**John H. Mueller**  
Senior Vice President and  
Chief Nuclear Officer

February 7, 2000  
NMP2L 1932

RE:                   Nine Mile Point Unit 2  
                          Docket No. 50-410  
                          NPF-69  
                          TAC No. MA7119

**ATTACHMENT A**  
**MARKED-UP ITS PAGES**

Figure 3.4.1-1 (Page 1 of 1)  
Stability Monitoring Power-to-Flow Map

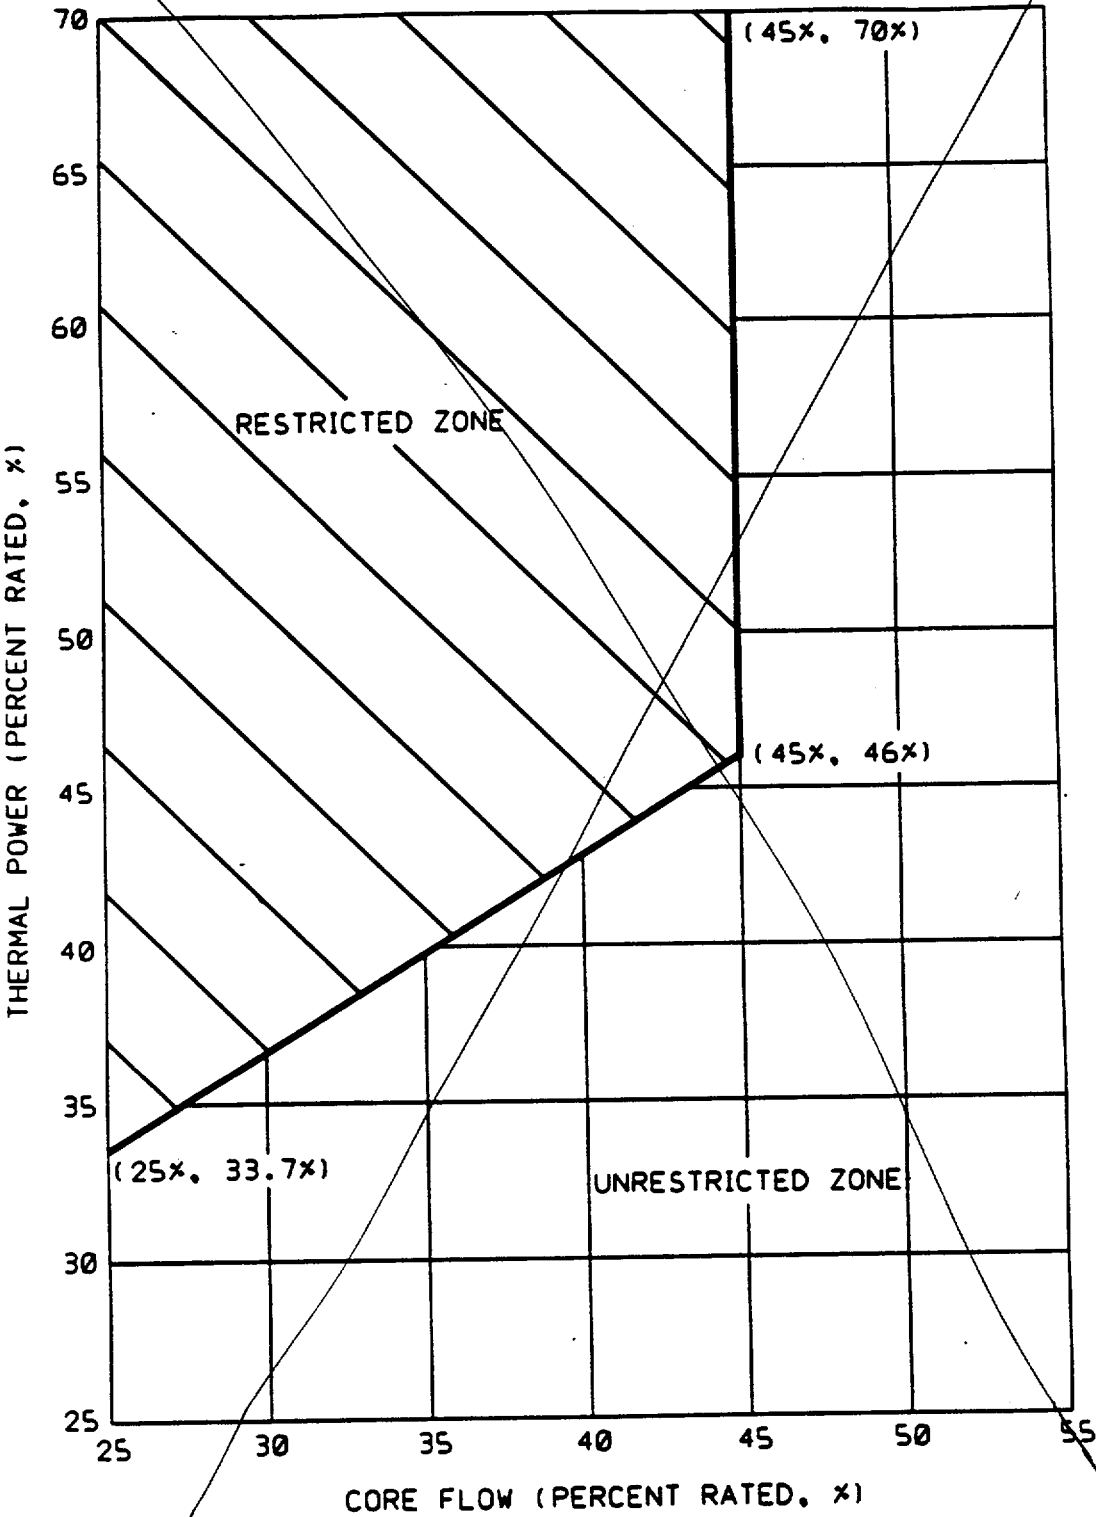
LCO 3.4.1 Two recirculation loops with matched flows shall be in operation ~~in the "Unrestricted Zone" of Figure 3.4.1-D,~~

One recirculation loop shall be in operation ~~in the "Unrestricted Zone" of Figure 3.4.1-D~~ with the following limits applied when the associated LCO is applicable:
